April 19, 2024

ADDENDUM No. 3

REC LIGHTING PROJECT - PICKLEBALL COURTS & PARKING LOTS - 2024

ELECTRICAL PLAN

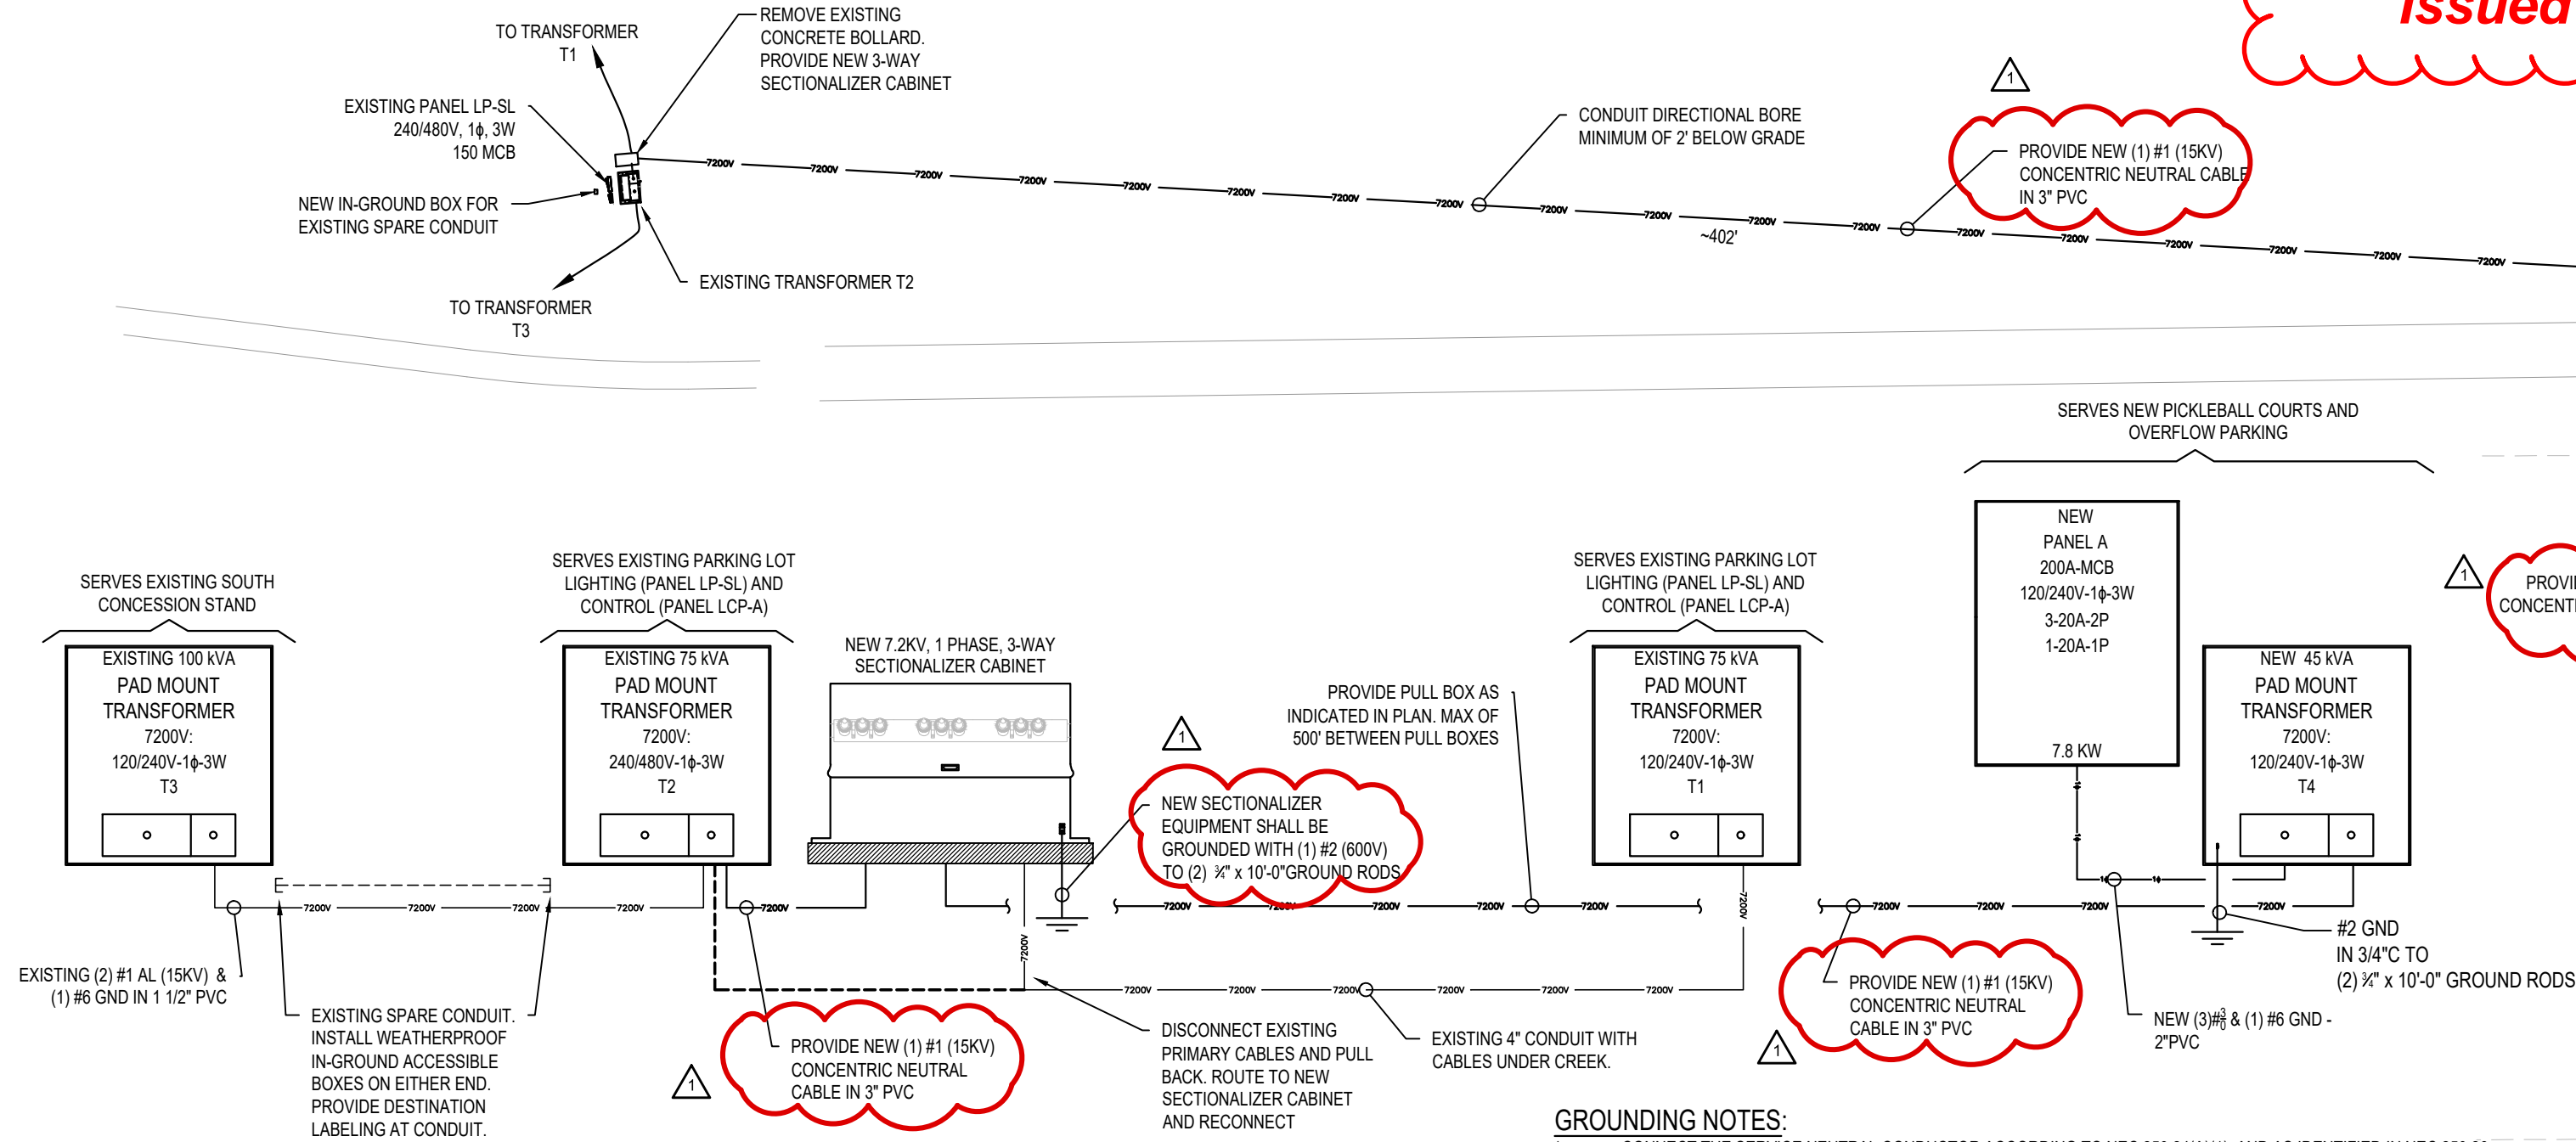
1) See Revised Drawing E1.1 (ADDENDUM NO. 3)

Replace Drawing E1.1 with the attached revised Drawing E1.1 (ADDENDUM NO. 3 4/19/24).

General recap of the changes:

- Eliminate two (2) parking lot poles on the west side of parking lot by drive.
- Two (2) parking lot poles on the east side of parking lot become alternate #2, including the feeders.
- Reroute of the base bid conduit
- Addition of 2 pole 20A breaker so each base bid parking lot pole has its own branch circuit.
- Conduit size revised for light pole feeders to be a minimum of ¾". (Contractor may use a larger size if they elect.)

- 2) **Note:** All conduit can be installed by either directional bore or trenching method. For either method, the contractor will be responsible for restoration of any disturbed areas, including final grading and seeding. For trenching through any future parking lot areas, contractor will be required to install granular backfill with proper compaction. Any trenching through the parking lot areas must be completed prior to July 1, 2024 before the 12" of millings are planned to be installed by separate contractor.

Note: All conduit can be installed by either directional bore or trenching method. For either method, the contractor will be responsible for restoration of any disturbed areas, including final grading and seeding. For trenching through any future parking lot areas, contractor will be required to install granular backfill with proper compaction. Any trenching through the parking lot areas must be completed prior to July 1, 2024 before the 12" of millings are planned to be installed by separate contractor.
